REQUEST FOR INFORMATION (RFI)

PROJECT :	BKK2	R.F.I. NO. :	523213-01-RFI-AR-0010
TO :	CTA	ATTENTION :	CTA
SUBMITTED DATE:	20-Jan-26	NEED REPLY BY DATE :	27-Jan-26

SUBJECT : Request for Confirmation - Indicate Wall Structure and Wall Finishes Type for Batt S2, S3 and EE Room 6th Floor

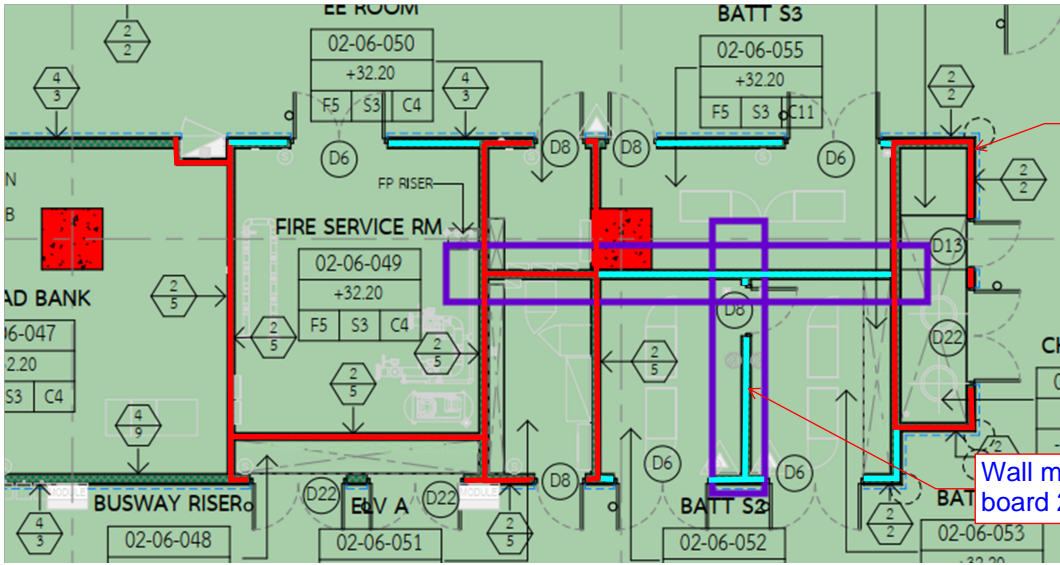
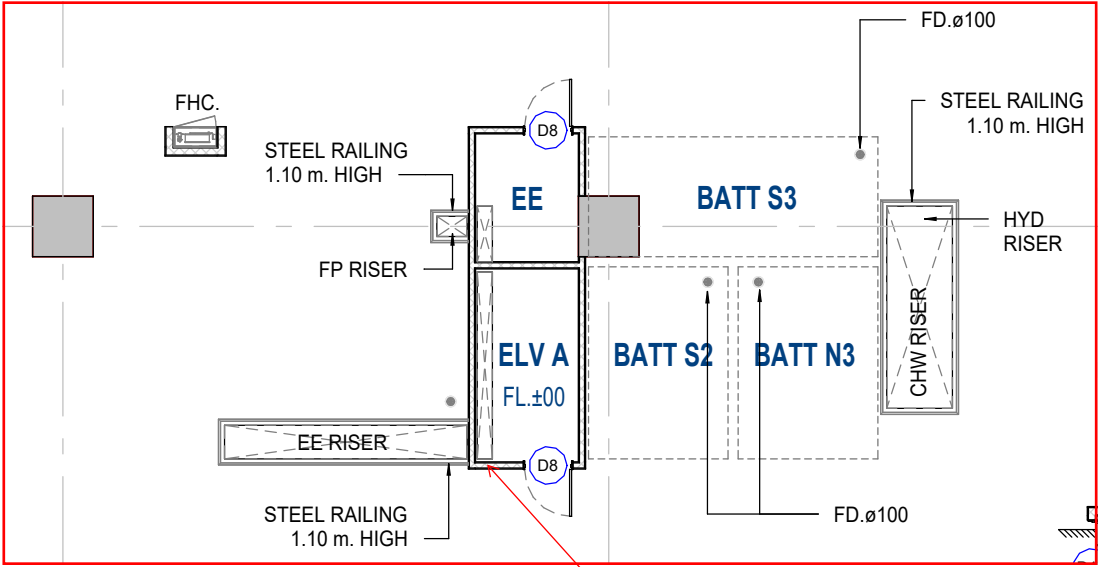
Indicate wall structure, wall finishes type for Batt S2, S3 and EE Room 6th Floor.

Wall material 2, block wa
2Hrs fire rated.

Wall material 4, gypsum
board 2Hrs fire rated.

Block wall by TTI.
